Prairie Island Nuclear Generating Plant, Units 1 and 2
Docket Nos. 50-282 and 50-306
Renewed Facility Operating License Nos. DPR-42 and DPR-60

Prairie Island Nuclear Generating Plant, Units 1 and 2 License Amendment Request:
Revision to Emergency Plan Staff Augmentation Response Times

**LICENSE AMENDMENT REQUEST:
REVISION TO EMERGENCY PLAN STAFF AUGMENTATION RESPONSE TIMES**

1. Proposed Emergency Plan Changes (Mark-up)
2. Proposed Emergency Plan Changes (Clean)
3. Letter of Concurrence from State and Local Authorities

Figure 1 Prairie Island Plant Emergency Organization

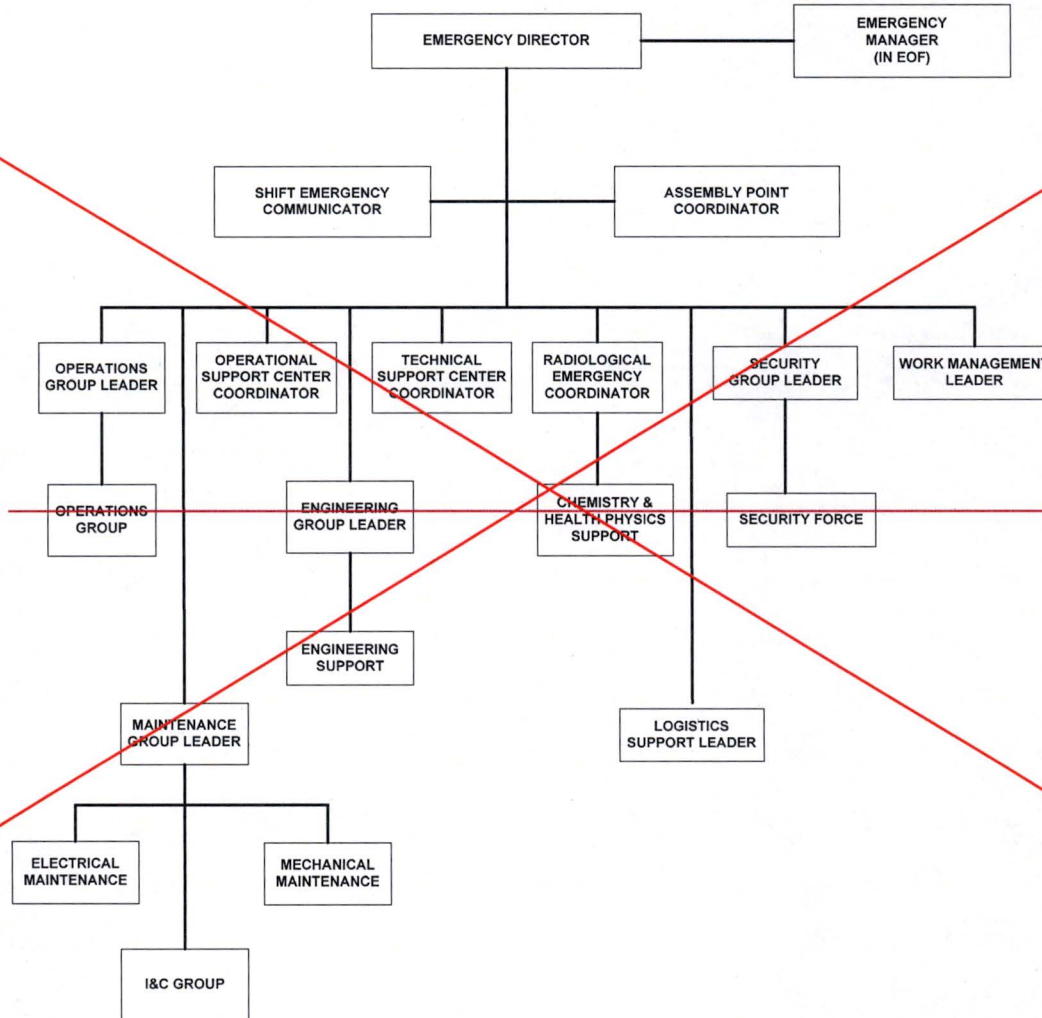
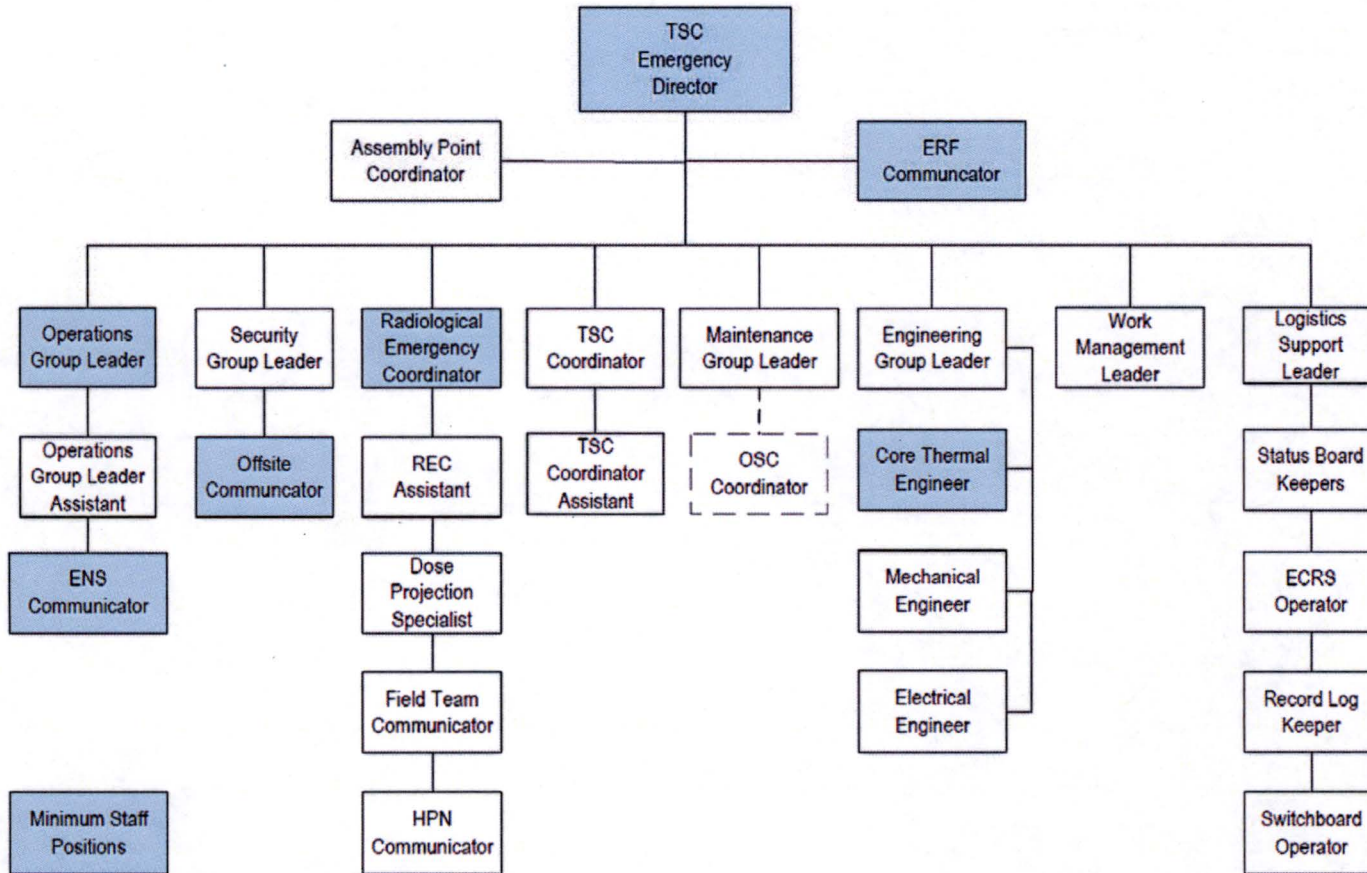
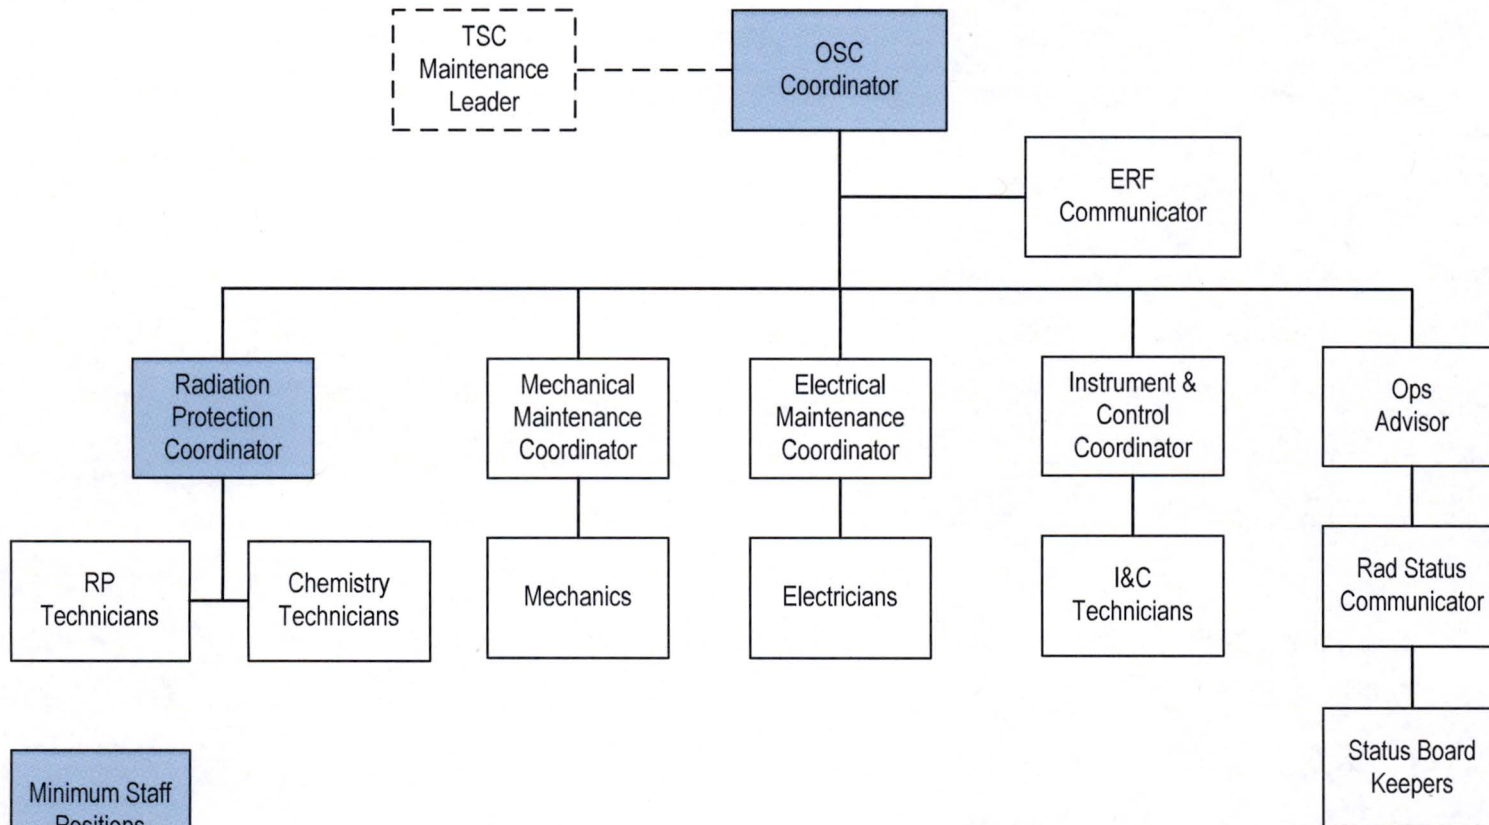
- f. Figure 1, "Prairie Island Plant Emergency Organization," was revised to reflect TSC and OSC positions including identification of positions required for facility activation.

Superseded entirely.
See revised Figure 1
on next 2 pages

The proposed revision to PINGP E-Plan, Figure 1, identifies the following minimum staff positions in the TSC needed to support activation of that facility within 60 minutes of an Alert or higher classification:

The proposed revision to PINGP E-Plan, Figure 1, identifies the following minimum staff positions in the OSC needed to support activation of that facility within 60 minutes of an Alert or higher classification:

Positions listed are 60 minute responders

Figure 2 Prairie Island EOF Organization

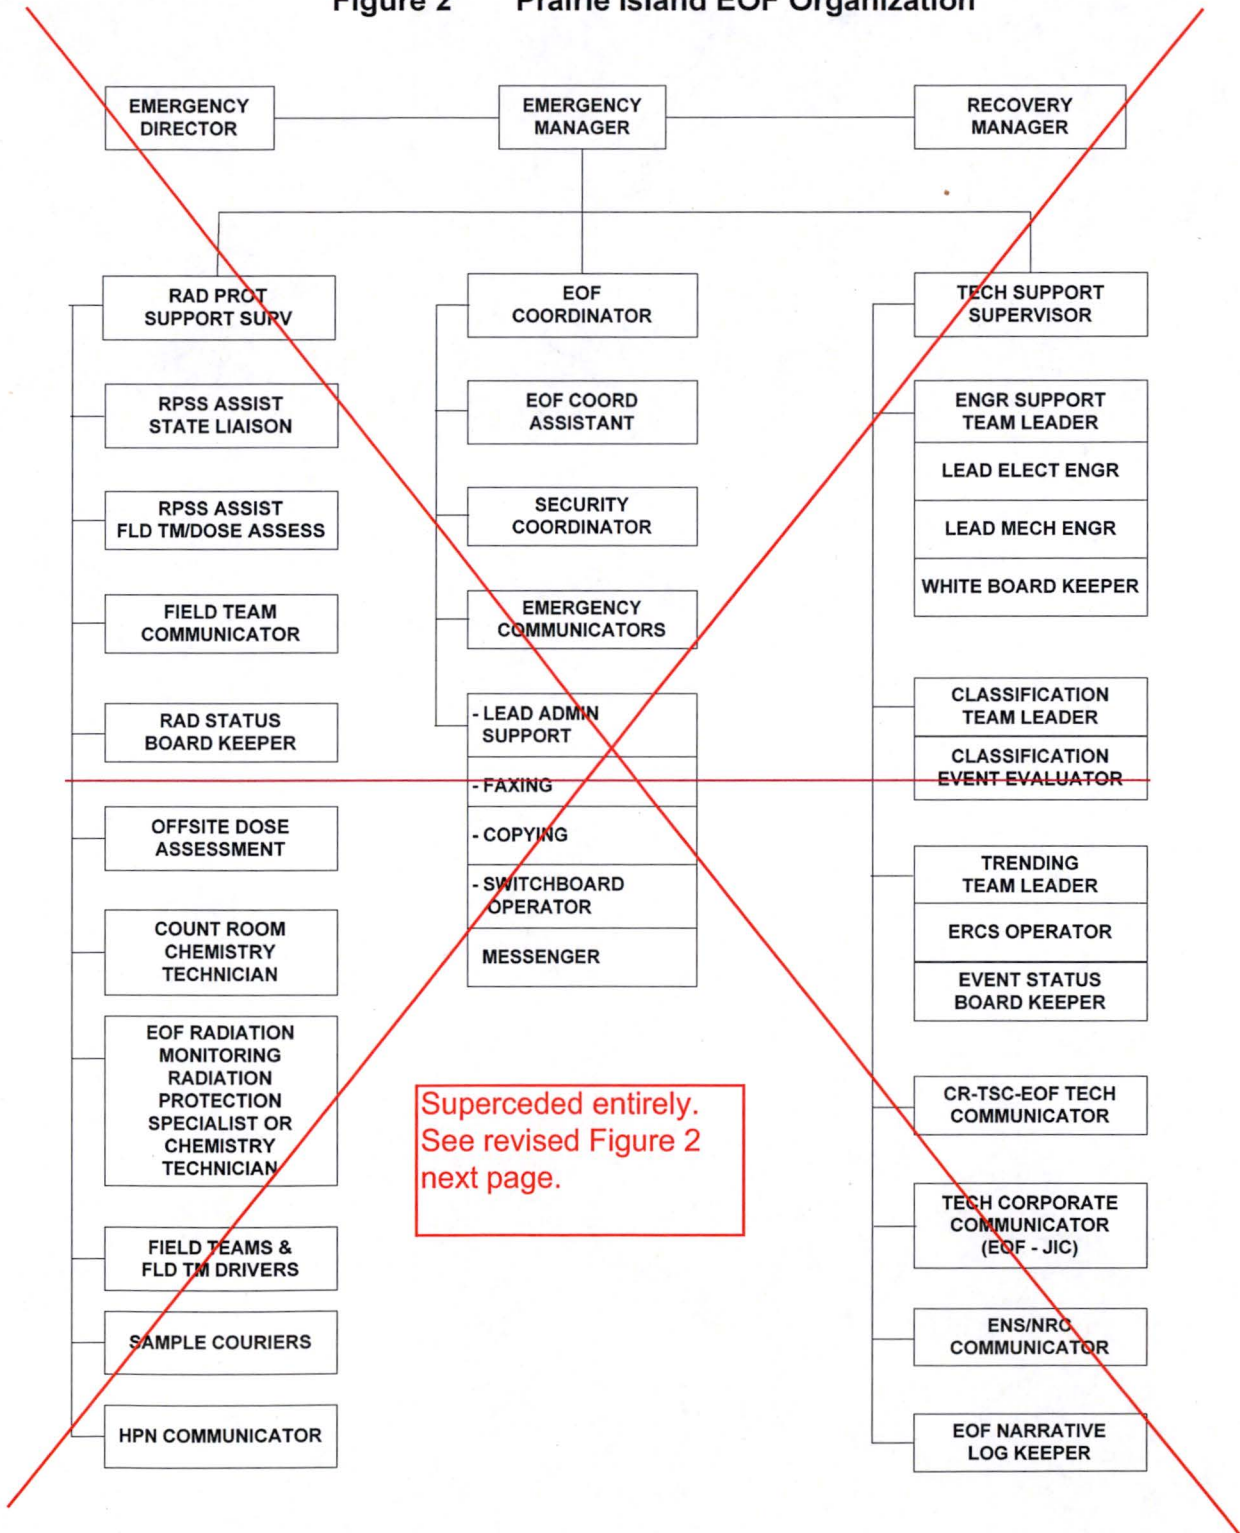
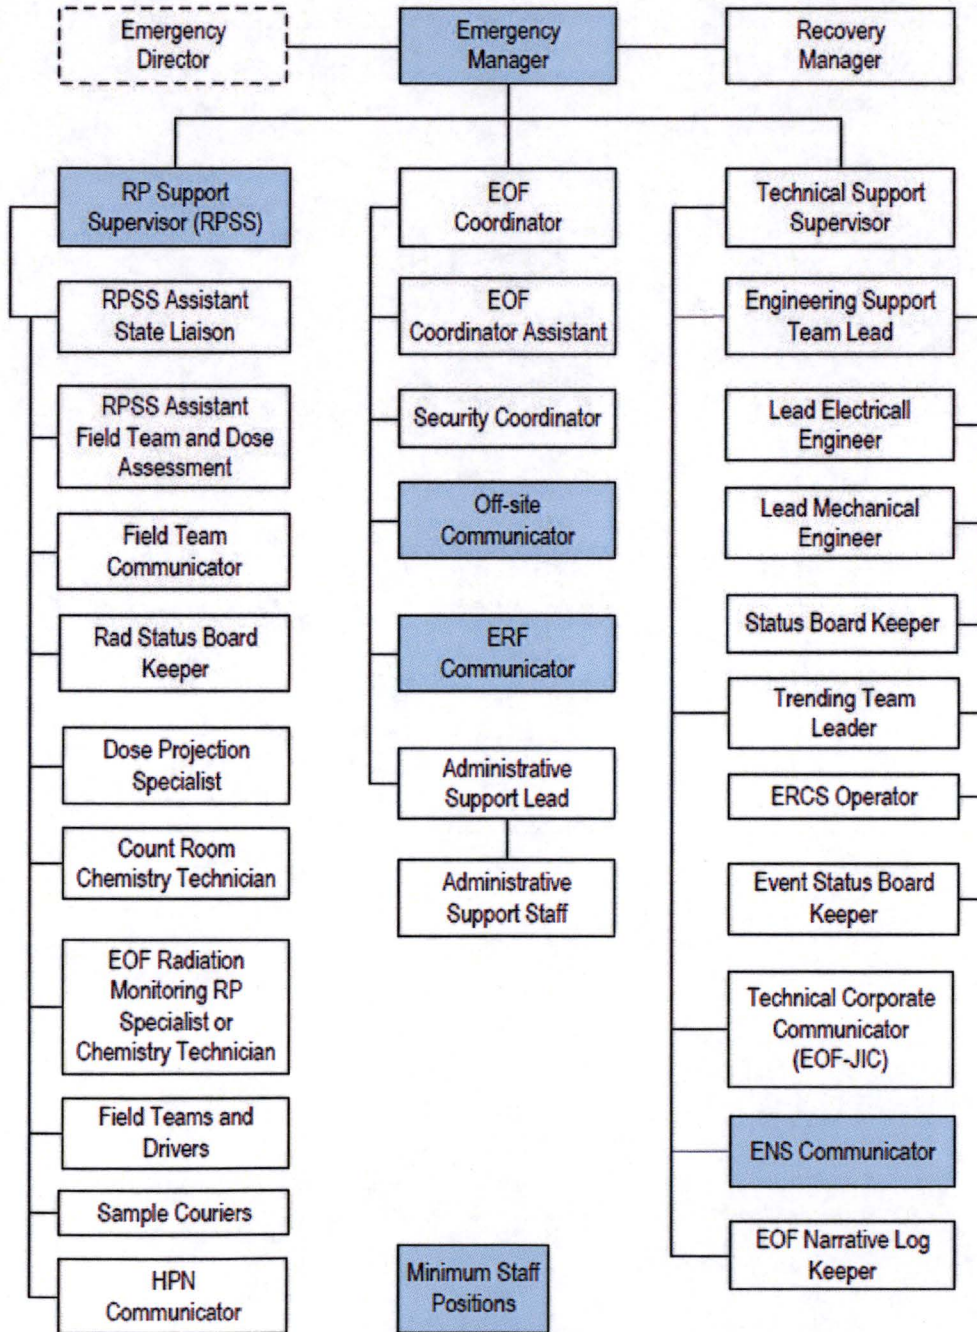
- n. Section 5.4, "EOF Organization," revised to reflect 90-minute activation time consistent with extended staff augmentation change.
 - o. Figure 2, "Prairie Island EOF Organization," revised chart to reflect positions required for facility activation.

The proposed revision of the PINGP Emergency Plan, Figure 2, identifies minimum staff positions in the EOF which support activation of the facility within 90 minutes of an Alert or higher classification.

Positions listed are 90 minute responders
